#### **ADDENDUM #2**

Date: March 29, 2018

BELMONT BATTERY REHABILITATION

FORT RODD HILL, B.C. Project No: R.075097.001

SECTION 7 REVISED (REFER TO DWG. BB-S12)

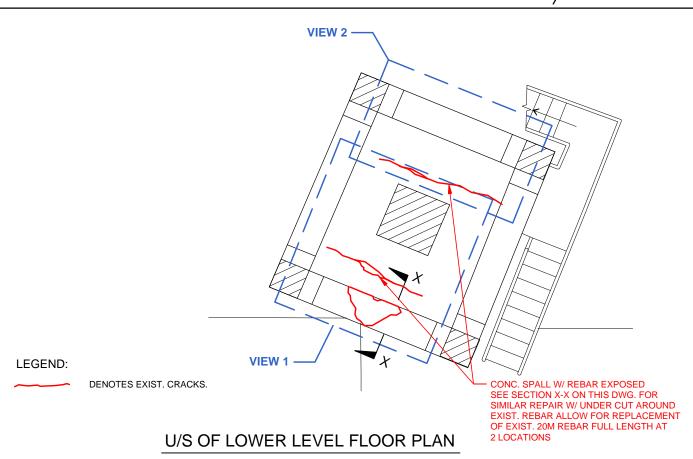
3.1 **Add** pocket infill to existing investigation opening as per attached addendum sketch AD-S02.

U/S OF LOWER LEVEL FLOOR PLAN ADDED (REFER TO DWG. BB-S42)

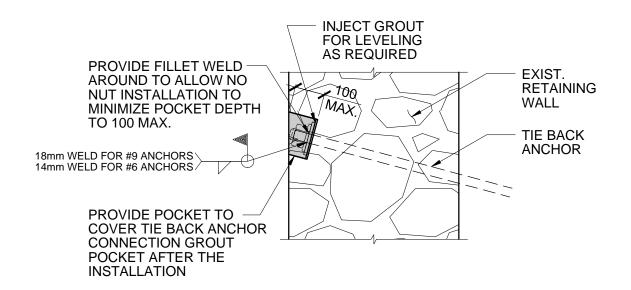
- 9.1 Add U/S of Lower Level Floor Plan as per attached addendum sketch AD-S03.
- 9.2 **Add** note "allow for replacement of existing 3-25M full length at two locations where existing rebar is found severely corroded" in Section X-X.

TYPICAL TIE BACK ANCHOR POCKET DETAIL ADDED (REFER TO DWG. SL-S40)

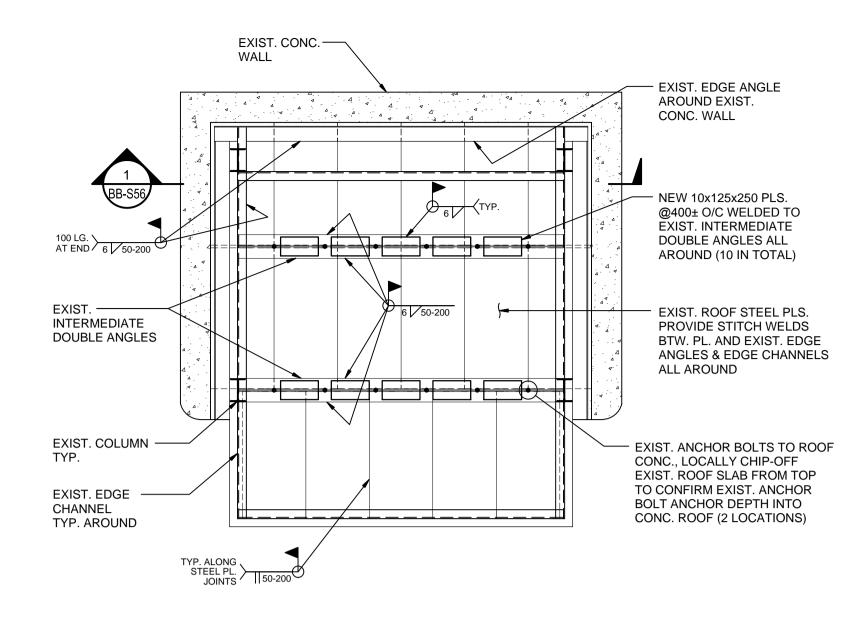
- 15.1 Add typical tie back anchor pocket detail as per attached addendum sketch AD-S04.
- 15.2 **Clarify** tie back anchor to be conformed to ASTM A706 500/550MPa weldable bars.

**DIRECTOR'S TOWER SEISMIC UPGRADE TO ROOF** & UPPER FLOOR WALLS

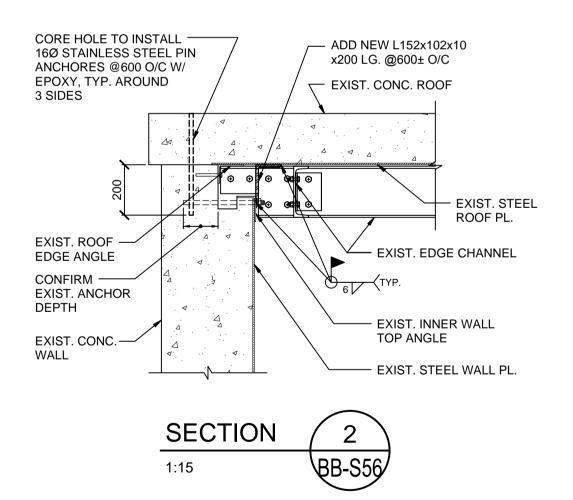
12.1 **Add** new drawing BB-S56 showing the seismic upgrade to roof and upper floor walls as per attached drawing BB-S56 issued for structural addendum No. 1.

**ELECTRICAL LOWER FLOOR PLANS**

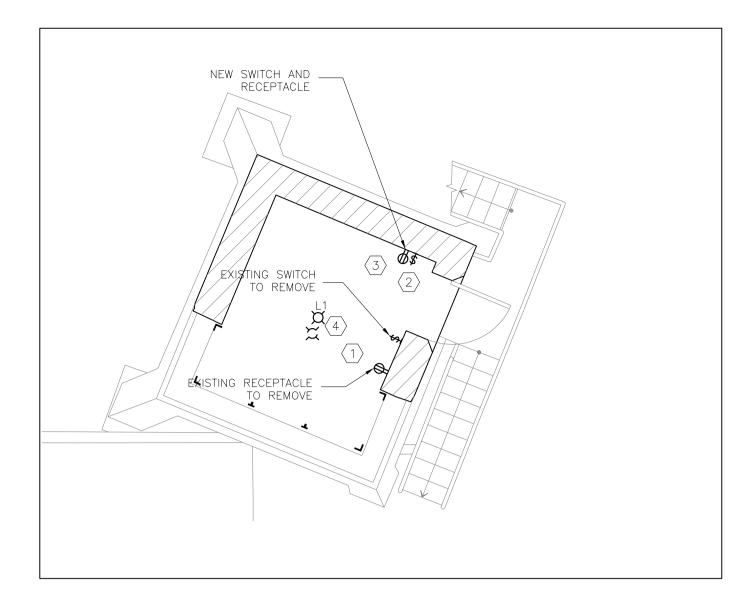
- a. Remove existing lighting switch in Belmont Tower. Refer to attached drawing E05 for details.
- b. Remove existing receptacle in Belmont Tower. Refer to attached drawing E05 for details.
- c. Install new lighting switch in Belmont Tower. Refer to attached drawing E05 for details.
- d. Install new receptacle in Belmont Tower. Refer to attached drawing E05 for details.
- e. Include for the removal of the existing light fixture and the installation of a new type 'L1' fixture. Include the removal of old conduit from the light switch and the installation of new conduit to the new light switch location.
